Subject: FW: [EXTERNAL]RE: Seattle Seahawks VMAC From: Roxanne Holt <Roxanne.Holt@vulcanhart.com> Date: 6/24/2021, 3:38 PM

Subject: Seattle Seahawks VMAC

Customer needs a countertop 48" Rapid Recovery with 2-OTB, but the kicker is they need it be to connected together with a common ledge.

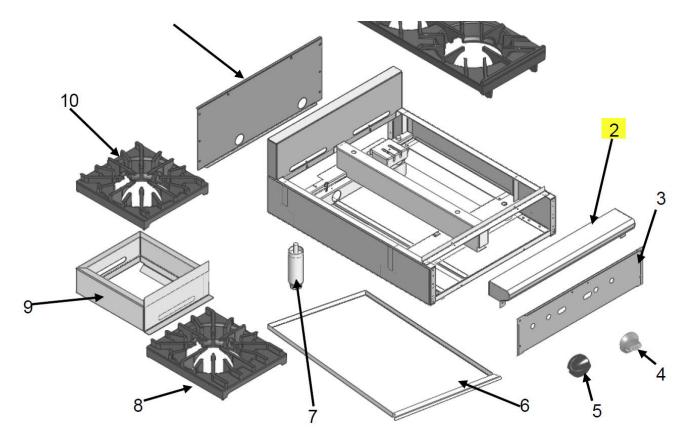
Can you put together a design that shows: MSA48 and a VHP212 with "a custom overlapping front top ledge" where it "looks" like all one unit? They will still be basically stand-alone unit, but they want it to "look" like, but a singular ledge across the two.

It looks like the ledges are similar! Let me know if you have any questions!
